Response to Submissions Report

Proposed Data Centre at 57 Station Road,
Seven Hills (SSD- 33781208)

SEPTEMBER 2022

Figure 1: Plan extract showing area of outdoor open space.
Source: Studio IZ

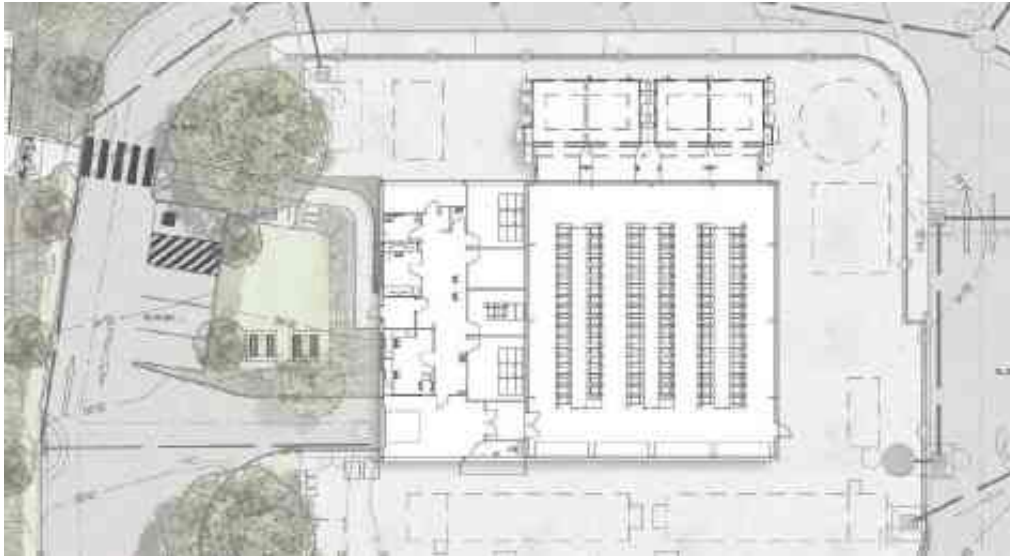
In the Department's RFI, a number of matters were raised in relation to urban design and visual aspects of the proposal. Specifically, this related to clarifications regarding the generator exhaust stacks, the northeast elevation façade treatment, the provision of outdoor recreational areas at the site, and the resolution of the visual impact assessment.

- A high-resolution version of the VIA has been provided as Appendix 12 of the RTS Report.
- As shown on the extract from the approved architectural drawings under DA-21-01058, a generous outdoor area for staff recreation is provided at the front of the SYD09.

Figure 2: Site plan showing inclusion of planting along the perimeter of the carpark
Source: Studio IZ

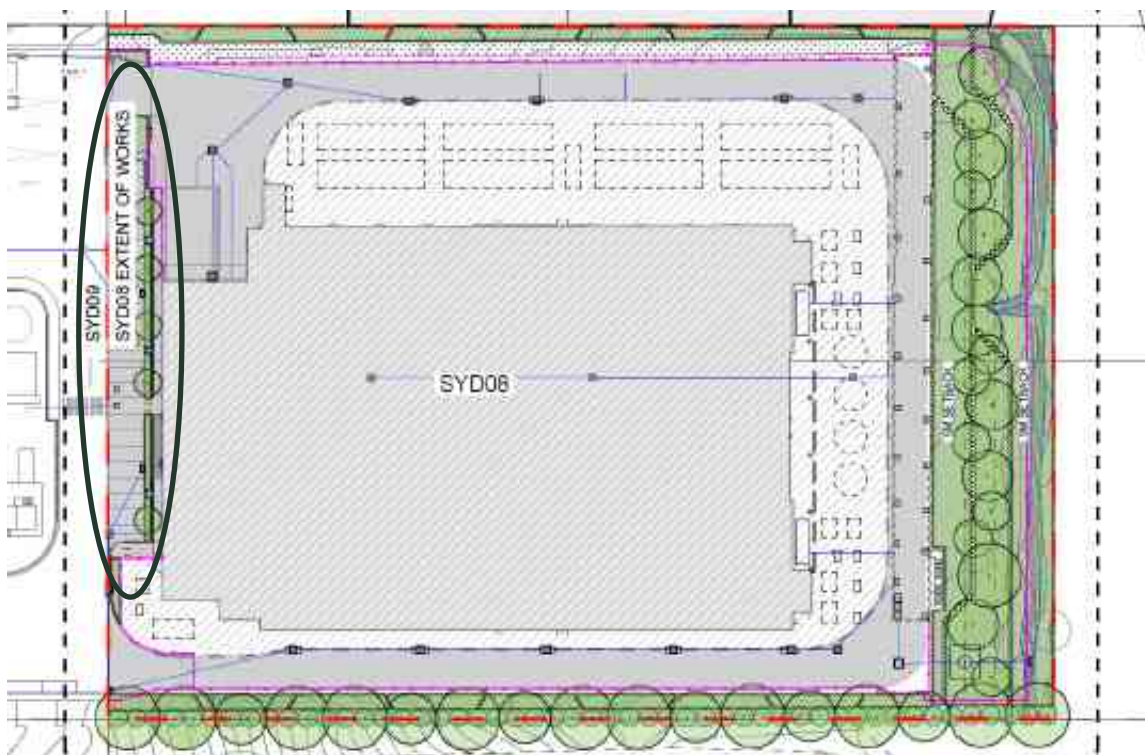
Council requested that a tree be provided for every 10m of carparking within the development to comply with the provisions of Section 4.2 of the Blacktown Development Control Plan (BDCP) 2015.

In response, the landscaping design has been amended to provide for five (5) new trees in the car parking area which is approximately 60m in length. Whilst it is acknowledged that strict compliance with the BDCP 2015 control is still not achieved, the solution is considered acceptable as:

- With the introduction of new planting, the departure from the DCP control will ultimately be minor, with 5 trees provided when 6 trees are otherwise required. Furthermore, it is noted that DCPs technically do not apply to SSDAs.

Figure 4: Concept plan demonstrating potential for additional parking to be provided
Source: DEM Architects

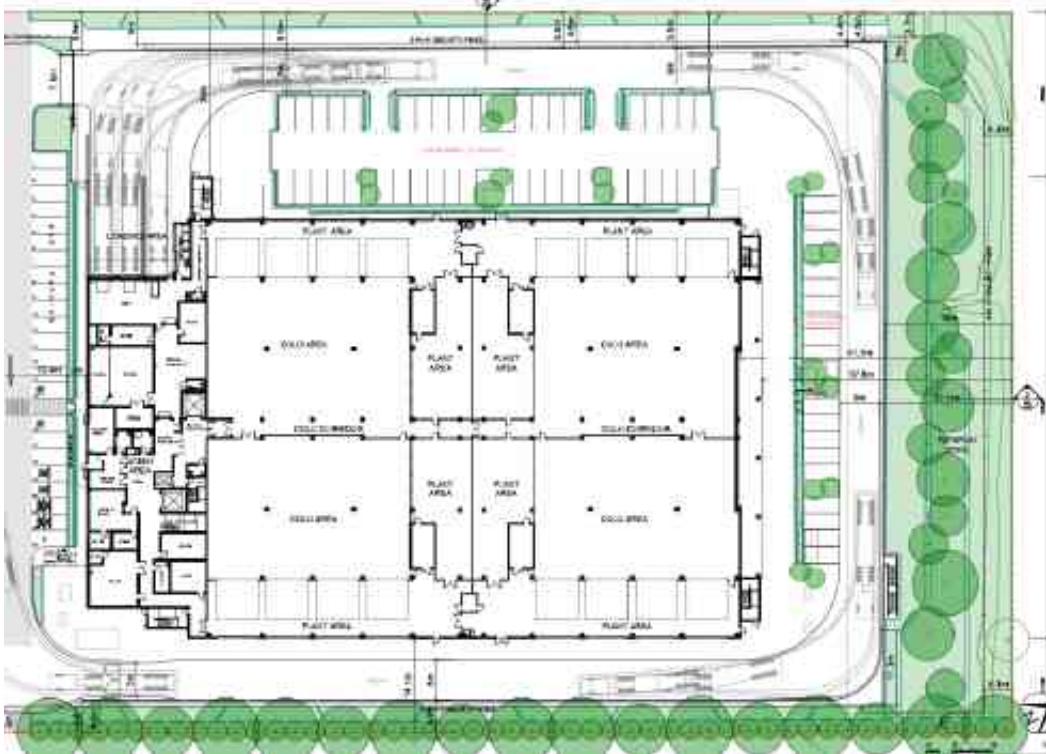
Council's submission raises concern with the proposed provision of an additional 15 car parking spaces, resulting in the whole site being serviced by a total of 31 car parking spaces. Council requested that the development comply with the car parking rates for industrial and office developments under BDCP 2015, requiring the provision of a total of 85 car parking spaces overall.

Council's submission acknowledges that the predicted staff numbers for the data centre would not demand this number of spaces, however they are of the opinion that there is the potential for the building to change use in the future.

Notwithstanding the above, the applicant agreed with Council following the receipt of its submission that an acceptable outcome would be to demonstrate the site's potential to provide for additional parking should a future change of use occur. As such, DEM have prepared a concept plan (Appendix 5) which identifies that the rear portion of the site could provide 86 car parking spaces by utilising areas currently dedicated to plant equipment.
